STAFF REPORT

SUBJECT: H-2021-0019 & A-2021-0063
Mountain America Credit Union – CUP & DES

Conditional use permit for a drive-through establishment within 300-feet of another drive-through establishment on 1.16 acres of land in the C-G zoning district and concurrent Administrative Design Review.

A. Proposed Site Plan (dated: 3/23/2021)

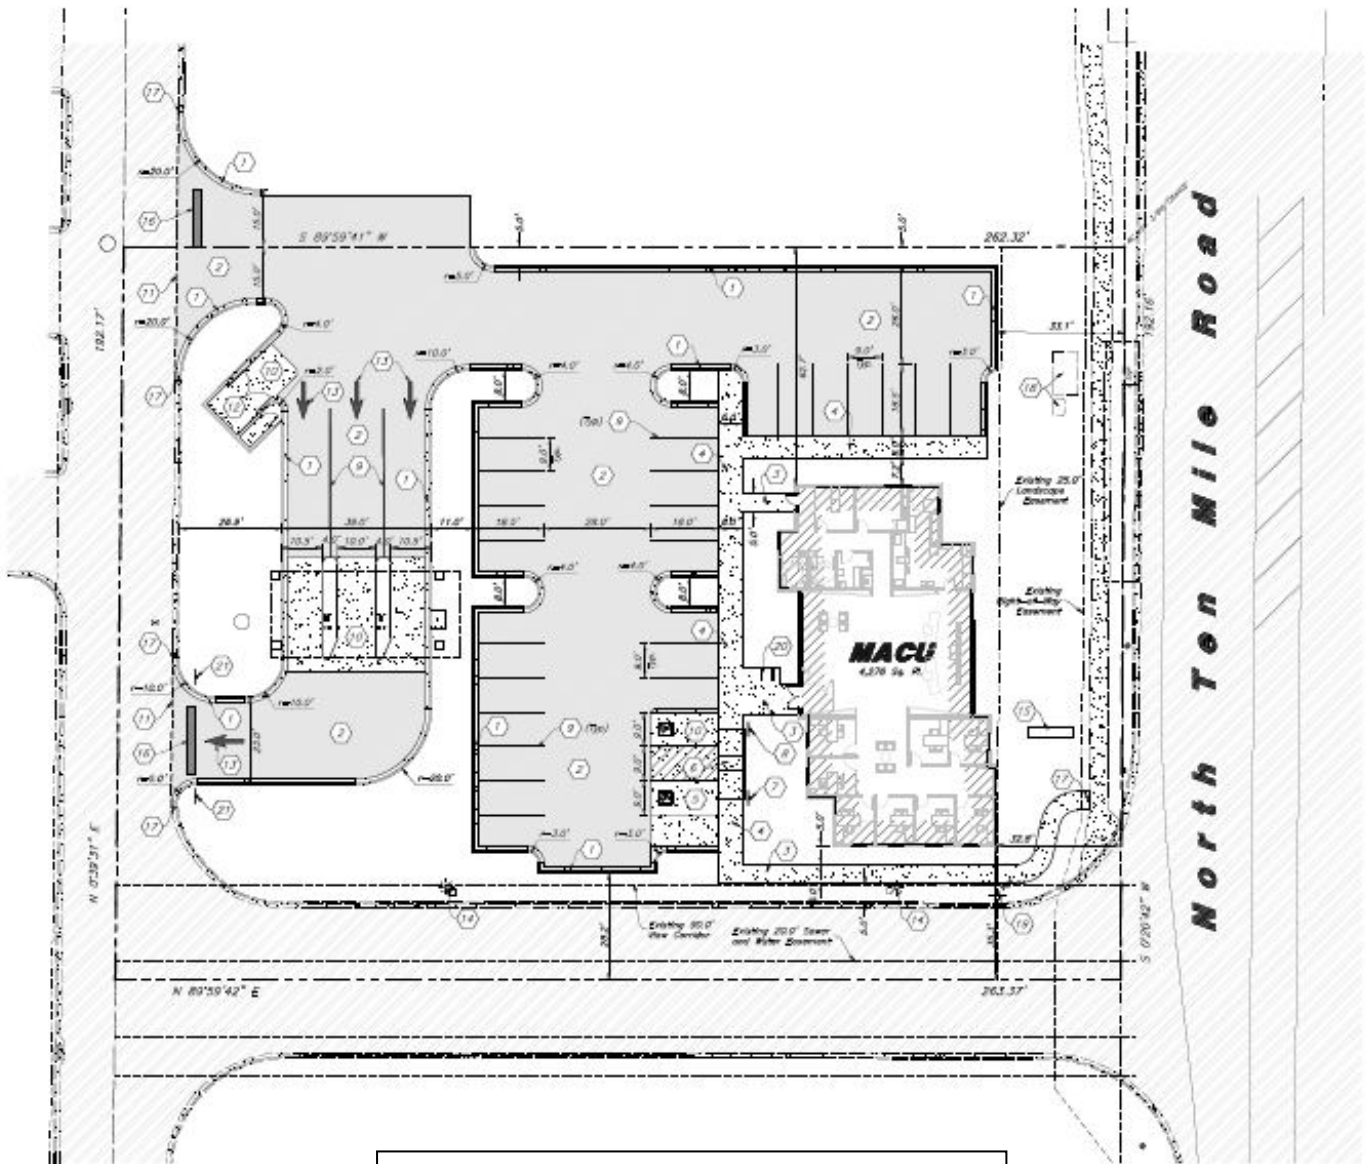
The proposed drive-through has three (3) stacking lanes that are approximately 65’ +/- from the drive aisle to the drive-up services for the bank; furthermore, the proposed drive-up services are proposed in a detached structure that is on the west end of the site with the main building being on the east of the site, approximately 95’ apart. Staff believes the stacking lane has sufficient capacity to serve the use without obstructing driveways and drive aisles by patrons.

Per the submitted site plan, the stacking lanes are off of the shared internal access and provide at least 65’ of are before any vehicle would impede any access. Staff does not foresee the stacking lanes impeding the circulation lanes, especially due to the proposed design of a detached drive-through.

The stacking lanes do not exceed 100' in length so no escape lane is proposed. However, the exit drive-aisle for the detached drive-through is shown as 23' wide, allowing for patrons to exit the drive-through and turn north or south with ample room on either side.

The detached drive-through is not exceptionally visible from N. Ten Mile Rd. (the closest public street) along the east boundary of the site but the south boundary of the site is one of the main ingress and egress drive aisles for the overall Costco site. Staff finds this shared drive-aisle and overall proximity to Ten Mile Road (no more than 185 feet in distance) provides for adequate surveillance opportunities.

Parking: A minimum of one (1) parking space is required to be provided for every 500 square feet of gross floor area for nonresidential uses. The proposed building is shown as 4,276 square feet requiring a minimum of 9 (rounded up from 8.5) parking spaces; the submitted site plan shows 30 proposed parking spaces exceeding UDC minimums.

Pedestrian Walkways: A pedestrian walkway is depicted on the site plan from the arterial/perimeter sidewalk along N. Ten Mile Rd. to the main building entrance as required by UDC 11-3A-19B.4a and meets code as submitted.

2. The site plan submitted with the future Certificate of Zoning Compliance application shall be revised as follows:
 - a. Depict the parking stalls in accordance with [UDC Table 11-3C-5](#) to be at least 9' wide and 19' deep unless there is at least a 2' overhang in front of the stall allowing the stall depth to be reduced to 17'.

- b. If 17' stall depths are desired abutting the proposed building, depict the sidewalk to be at least 7' in width; all sidewalks shall be at least 5' in width.

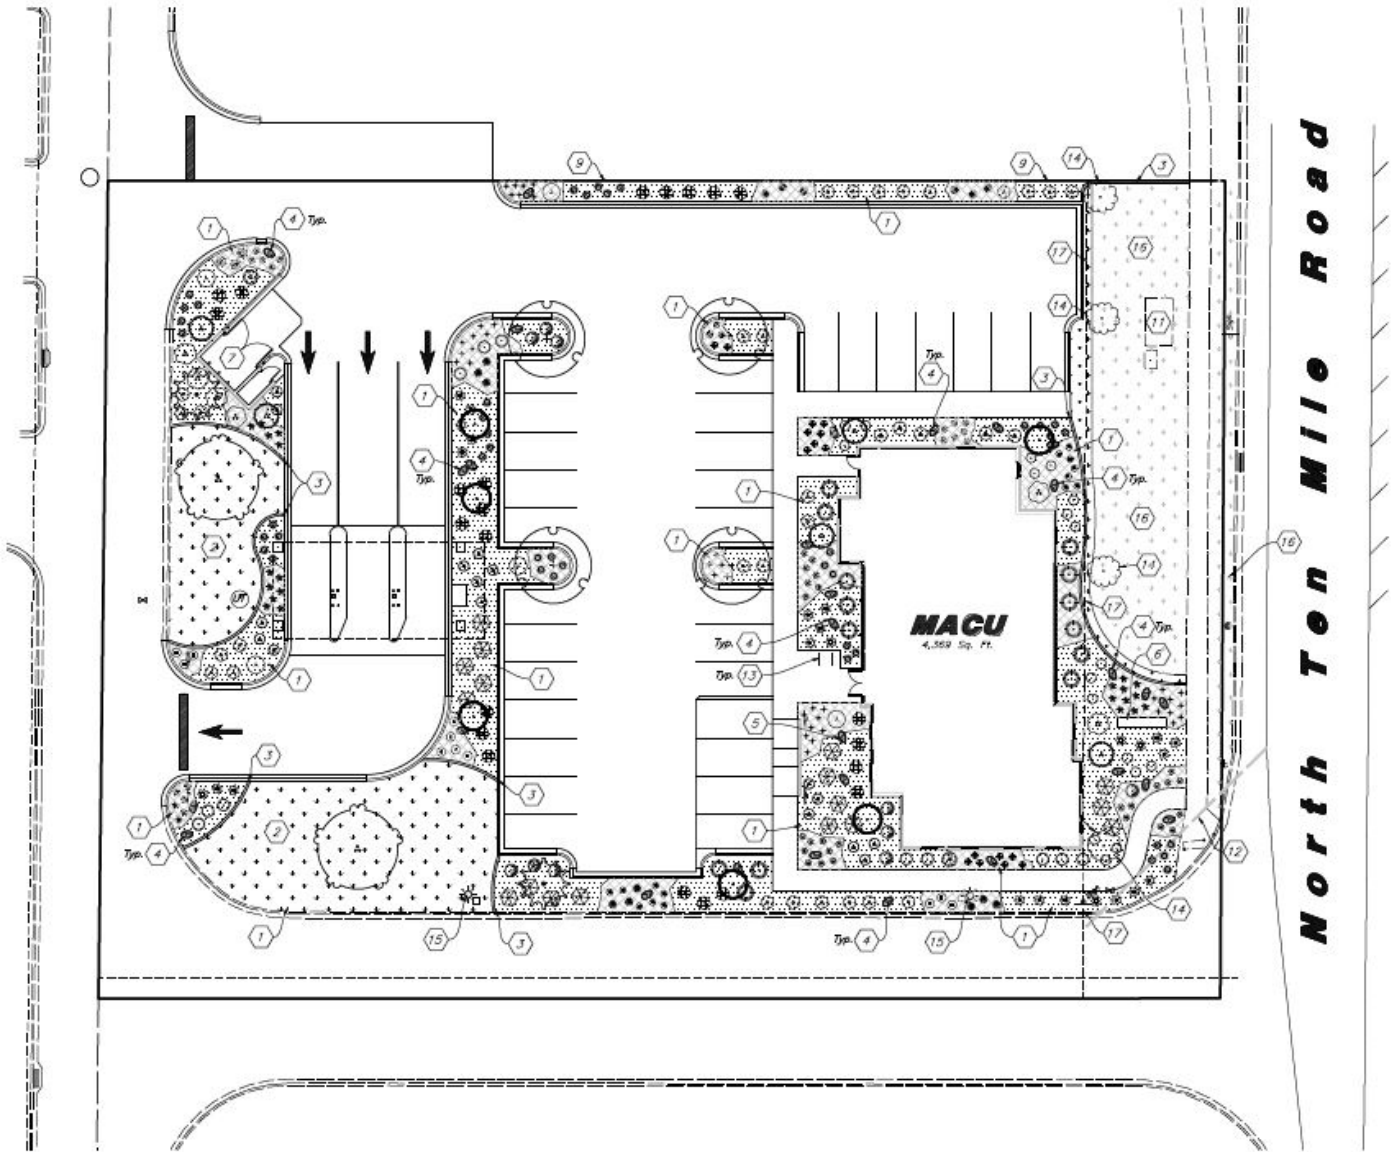
A minimum 5-foot wide landscape buffer is required to be provided along the perimeter of the parking or other vehicular use areas as set forth in UDC 11-3B-8C.1. The submitted landscape plan shows the required perimeter buffer but the buffer along the north boundary does not show any trees within this buffer. Trees are required to be provided for within these buffers at a ratio of at least 1 tree every 35 linear feet. **With the CZC submittal, the landscape plan should be revised to show compliance with this standard.**

Street buffer landscaping, including a sidewalk, along N. Ten Mile Rd. was installed with development of the overall subdivision. The submitted landscape plans show a majority of this buffer remaining as it currently exists but towards the southern end of this buffer the plans show additional landscaping to highlight the building and future monument sign. This area of the buffer also contains the new sidewalk connection from the existing sidewalk along Ten Mile to the front of the proposed building.

3. The landscape plan submitted with the future Certificate of Zoning Compliance application shall be revised as follows:
 - a. Depict the required number of trees within the planter bed along the north boundary, per UDC 11-3B-8.
